**Warehouse Development at  
College Lane, Greenogue,  
Rathcoole**

**Flood Risk Assessment**

**Final Report**

This letter addresses the request for the clarification of additional information in relation to planning application SD18A/0265 for a site in Rathcoole Co Dublin. The proposed development is for two industrial warehouses and associated parking facilities. Please find included below a response to Items 1 through to 4 of the South Dublin County Council Request for Clarification of Further Information.

Figure 1: Revised Flood Mitigation Design Schematisation

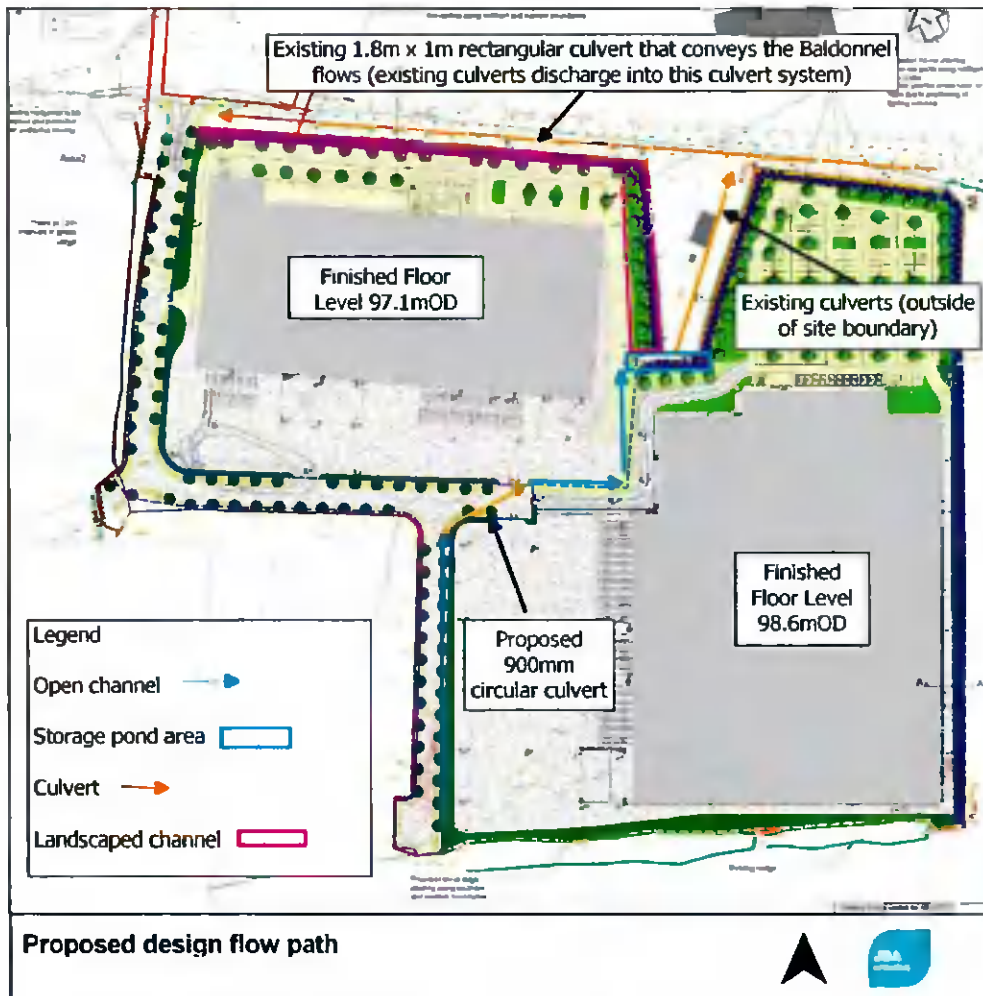
Item	SDCC Comment	JBA response
1	<p>In response to the request for further information, the applicant has proposed to reduce the finished floor level of block A by 1 metre. This is not compatible with the necessity to raise the finished floor level to 500mm above the highest known flood levels, which the Planning Authority would require as a measure to mitigate against any flood risk.</p> <p>The applicant is therefore requested to reconfigure the blocks on the site in order to avoid locating within Flood Zones A or B.</p>	<p>The finished floor level (FFL) of block A has been further revised and raised by 300mm from the amended levels to a final FFL of 97.10mOD. In response to Item 3 the flood mitigation design for the site has been updated and assessed within a site-specific hydraulic model. Results from the revised model confirm a freeboard greater than 500mm between the FFL and the maximum water level during the 1% AEP plus climate change flow event on site.</p> <p>The revised flood mitigation design replicates the attenuation and conveyance of overland flow mechanisms as predicted during modelling of existing greenfield conditions. The proposed flood mitigation design confines the overland flow within a specified easement that is routed around all hardstanding area within the development. Both blocks on site are therefore removed from Flood Zone A or B, with all development on site located within Flood Zone C. This approach is consistent with other sites within Greenogue Business Park which have previously been granted permission from SDCC, including; Site 517A, Site 522, Site 527 and Site 662.</p>

3	<p>The Planning Authority has concern that the proposed culverting of the stream that runs through the centre of the site would have significant effects resulting from the rapid transport of flood waters downstream.</p> <p>Furthermore, the proposed culvert is contrary to Development Plan policy on green infrastructure and retention of landscape features. The applicant is requested to address this issue.</p>	<p>This comment has been noted and taken in to consideration within the revised flood mitigation design. In the revised design the watercourse remains as open channel across the site. A proposed re-alignment of the channel increases it's overall length by c. 30m, increasing travel time and attenuation within the watercourse, thereby reducing potential for negative impacts of flood waters downstream.</p> <p>A culvert 900mm in diameter and c. 25m in length however is still included within the centre of the site as a requirement for internal road access. This culvert has been robustly tested within the hydraulic model which confirms no increase to flood risk.</p>

As depicted in Figure 1, the watercourse is proposed to be realigned through the site. The watercourse will predominantly remain as an open stream as per the requirements of SDCC. It is proposed that a single 900mm culvert c. 25m in length will be included to allow internal traffic flow over the watercourse. The total channel length is increased by 30m compared to the existing channel on site.

During extreme flood events such as the 1% AEP flood event and when the capacity of the existing culverts downstream of the site are exceeded, the excess flow will be directed into a shallow open diversion surface flow channel that runs around the northern boundary of the site. The diversion channel has been designed to replicate the existing greenfield flood behaviour onsite. The diversion flow channel is activated only during high flow events and is controlled by a set spill height of 96.50mOD. The diversion flow channel is contained by a boundary wall and a raised kerb on the left bank and the site boundary wall on the right bank. All are constructed of reinforced concrete.

Figure 2: Flood extents for the 1% AEP plus Climate change event

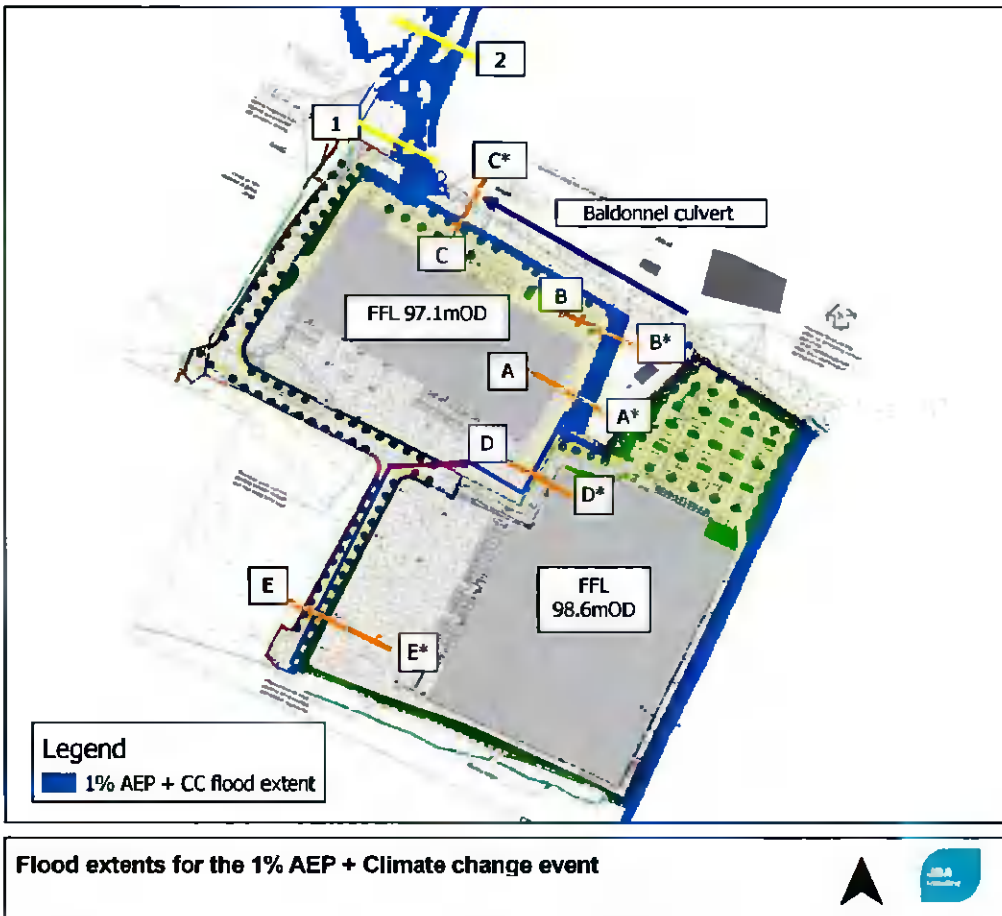
2	<p>Having regard to the large footprints of the proposed buildings and the large area of hardstanding associated with the car parking, the Planning Authority is not satisfied that the proposed development would not have significant flooding effects downstream. The applicant is requested to address this issue.</p>	<p>As noted in Section 5.4 of the Flood Risk Assessment, industry best practice is applied to attenuate all stormwater from hardstanding areas on site.</p> <p>This is clarified in email correspondence from Tim Cooke (JBA) to Brian Harkin (SDCC) on Friday 25th January 2019 and included in the response to the initial Additional Information request from SDCC.</p> <p>The stormwater design layout ensures all surface run-off is attenuated completed independently of any flood water mitigation measures or flows across the site, including the watercourse through the site. Surface run-off calculations and the surface water drainage network was provided within the application by Kavanagh Burke Consulting Engineers.</p>

Figure 2, Figure 3, Figure 4, and Figure 5 show the resulting flood water extents and cross sections along the watercourse and diversion channel with the corresponding water levels. From the cross sections provided the highest water level recorded is 96.59mOD (1% AEP CC) which is 500mm below the FFL of the proposed warehouse (97.10mOD). The design therefore provides sufficient freeboard to protect the building from the 1% AEP plus climate change event. Figure 6 and Figure 7 show a cross sections of the open channel upstream and downstream of the proposed culvert to the south of the site with the maximum water level recorded during the 1% AEP plus climate change event and Figure 8 shows the long section profile of the open channel section. The figures show the flow is contained within the channel upstream and poses no risk of flooding to the site.

The impact downstream of the site is also highlighted in Table 3-1 which compares the downstream flood levels and flows at the water level comparison line in Figure 2. There is no increase in downstream water level or peak flow observed when the existing and design scenarios are compared.
